**Subject:** Request for Modification for a Section 401 Water Quality Certification for SR 1001 (Connelly Springs Road) from US 321A (Norwood Street) to SR 1712 (Starcross Road) in Caldwell County. Federal Aid Project No. MA-STP-7533(2), Division 11, WBS 34783.1.1, TIP No. U-2211B. Debit \$570 from WBS 34783.1.1.

The North Carolina Department of Transportation (NCDOT) requests a permit modification to include additional temporary stream impacts from utilities for the above-referenced project. The proposed wetland and stream mitigation has not changed since the modified Individual Permit (IP) was issued in July 2012. Please see the attached utility drawings showing the location of the additional temporary impacts.

Utility  
 Permit Drawing  
 Sheet 2 of 3

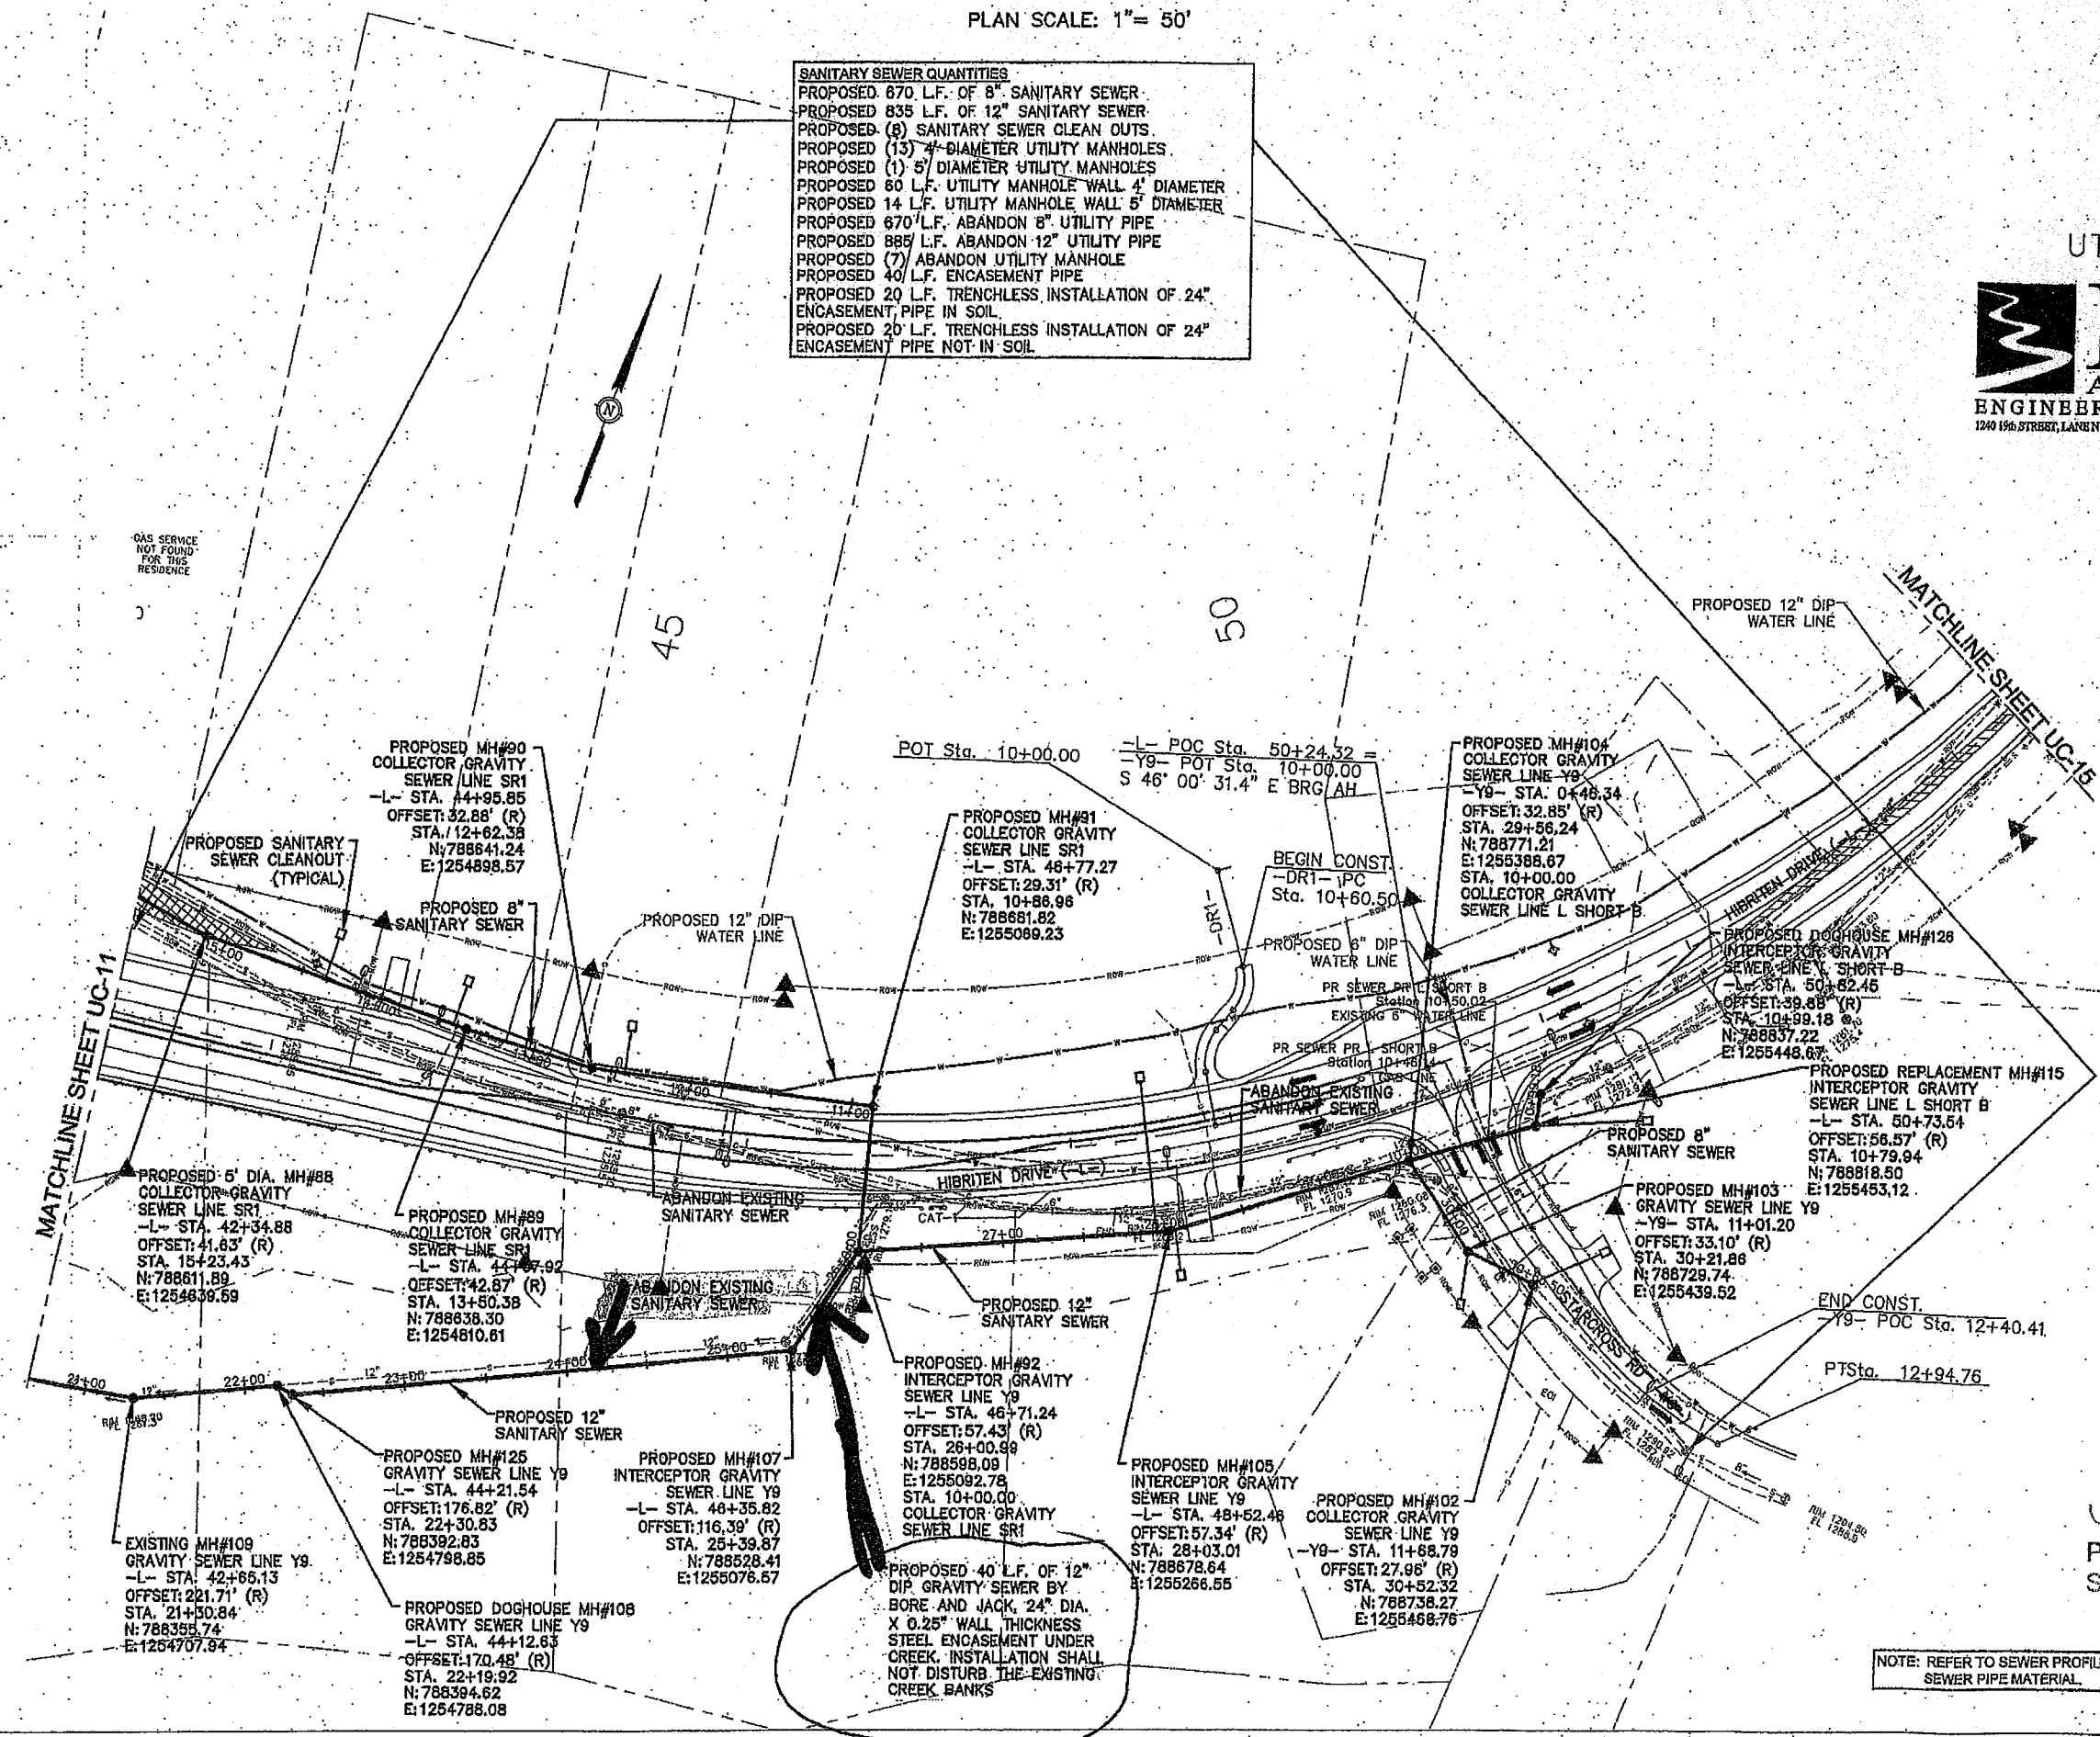
This project will permanently impact 0.24 acre of wetlands, 1,610 linear feet of streams, and temporarily impact 0.01 acre (93 linear feet) of streams. Previously, it was proposed that only 0.01 acre (53 linear feet) of stream were to be temporarily impacted. However, the NCDOT is requesting an additional 40 linear feet of temporary impact for dewatering to UT1 to Gunpowder Creek.

A new sanitary sewer line will be installed by an open cut trench adjacent to the Permit Site 3 impact. Therefore, the NCDOT is proposing 40 linear feet of dewatering for a dike and pump around operation while the new sewer line is being installed where it crosses the creek. Once the new line is laid and backfilled, the banks will be seeded and matted with coir fiber so there should be no permanent bank hardening impact. The new line will be laid below the streambed elevation (as shown on utility permit drawing 3 of 3).
